**OU1 Design Change and Modification Sheet:  
Change/Modification # 22**

Property ID: \_\_\_\_\_ Operable Unit 1 (Area 2)

CDM Federal Programs Corporation		 US ARMY CORPS OF ENGINEERS OMAHA DISTRICT RAPID RESPONSE PROGRAM	
Designed by: K. MAINZHAUSEN	 US EPA Region VIII Denver, Colorado	LIBBY ASBESTOS PROJECT LIBBY, MONTANA	
Drawn by: K. HUFFSMITH		OU1-REMEDIAL ACTION PROPOSED AREAS 2 & 3 RESTORATION PLAN	
Checked by: G. MCKENZIE		Scale: 1" = 100' Date: FEBRUARY 2012 Dwg. No.: 7	
Submitted by: G. MCKENZIE		Sheet number: C5	Plot Scale: Design File: File: K:\Libby OU1\DWG\September 2011 No.: AREAS 2 & 3.dwg

MOD #023

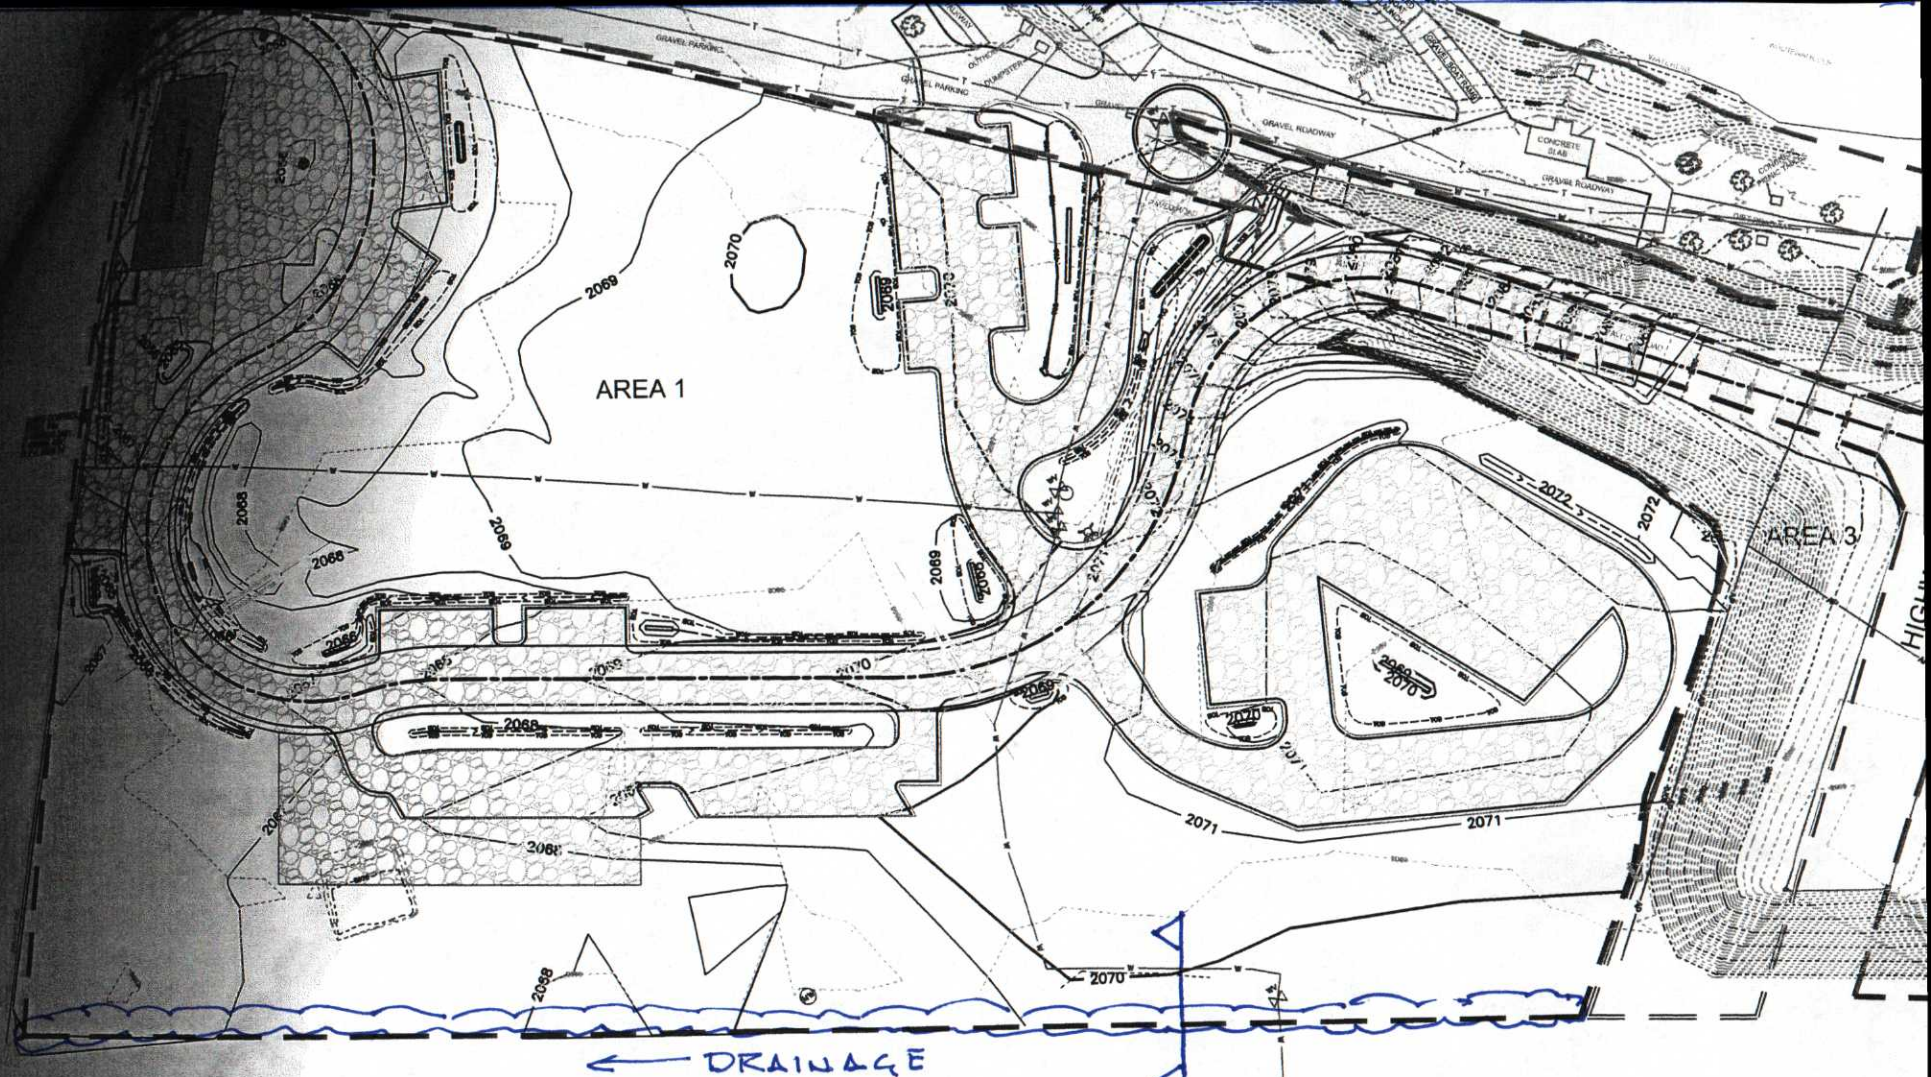
The final grade on the south perimeter of Area 1 where the City property adjoins the BNSF property will have a drainage feature installed along the southern boundary of Area 1 to direct run-off from the BNSF property to the pre-existing point of drainage discharge at the southwest corner of Area 1. The final grade elevations for the drainage feature will be recorded on the final as-build drawings.

LOW PROFILE BERM  
SECTION

MOD #24

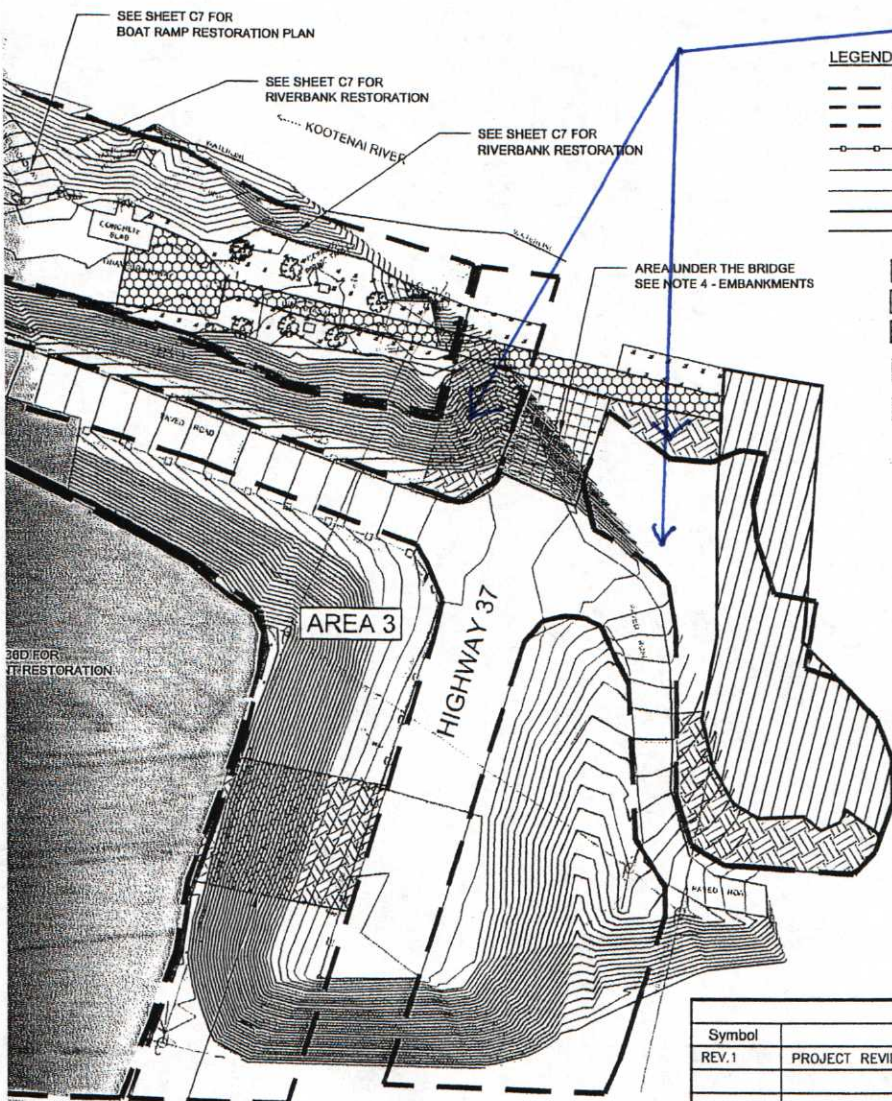
Sheet D1 Section 4 (typical), requires that 8" of common fill and 4" of topsoil be placed as replacement fill on the embankments adjoining Area 2. Excavation in area is designed for 6".

Replacement of fill material on these embankments will be with a minimum 6" of topsoil, the common fill is excluded on the referenced embankments.

EMBANKMENT  
AREAS TO BE BACKFILLED  
W/ 6" TOP SOIL

MOD #0260

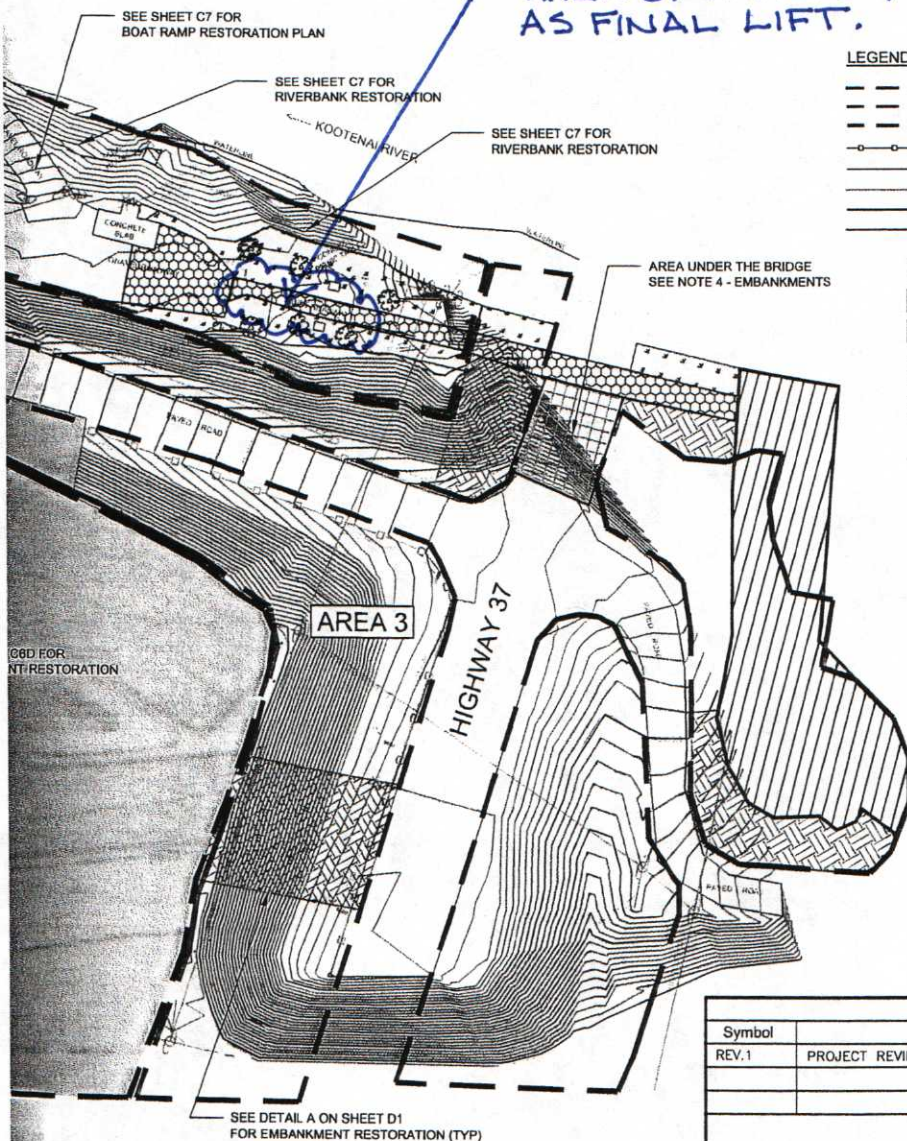
At the request of the City of Libby. Reference Sheet C5, the limits of the pathway on which  $\frac{3}{4}$ " minus crush base material is to be placed as the finish lift per the "crushed rock restoration section 2", on Sheet D1, is now to be changed to a 6" topsoil final lift commencing approximately at the western end of the power poles extending west to the eastern edge of the access ramp to the pump house.

AREA OF PATHWAY TO HAVE TOPSOIL (6") AS FINAL LIFT.
